# UNITED STATES PATENT AND TRADEMARK OFFICE

10/043,329

<b>Office Action Summary</b>	<b>Application No.</b>	<b>Applicant(s)</b>	
	10/043,329	BAEK ET AL.	
	<b>Examiner</b>	<b>Art Unit</b>	
	Steven H. Rao	2814

**FIG. 14**

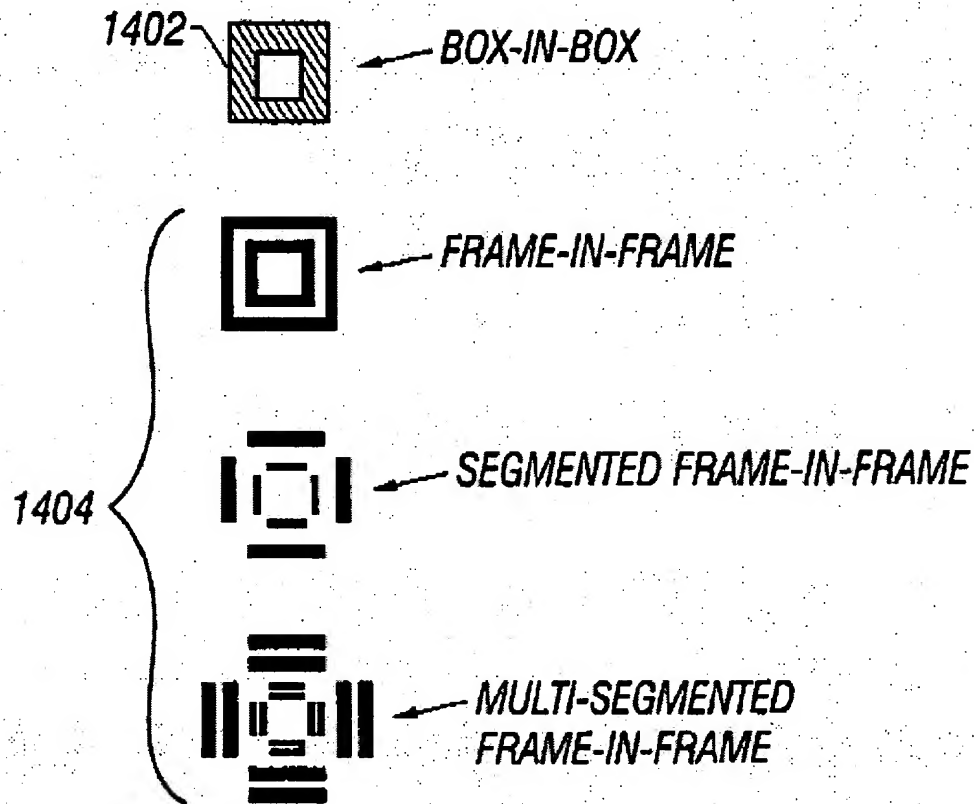
The same reason ( as stated under claim 4 above) has been repeated with respect to claims 4-5, 8-12 and 20 and is not persuasive for reasons set out above.. Applicants' arguments with respect to claims 14,18 and 21 that Smith figure 14 does not appear to show a length of first main overlay pattern is equal to a length of a corresponding side of the second main overlay pattern is at odds with figure 14 reproduced below – see especially the multi segmented frame-in-frame wherein first and second pattern are identical forming a square.

Therefore claims 14,18 and 21 are not patentable over the prior art.
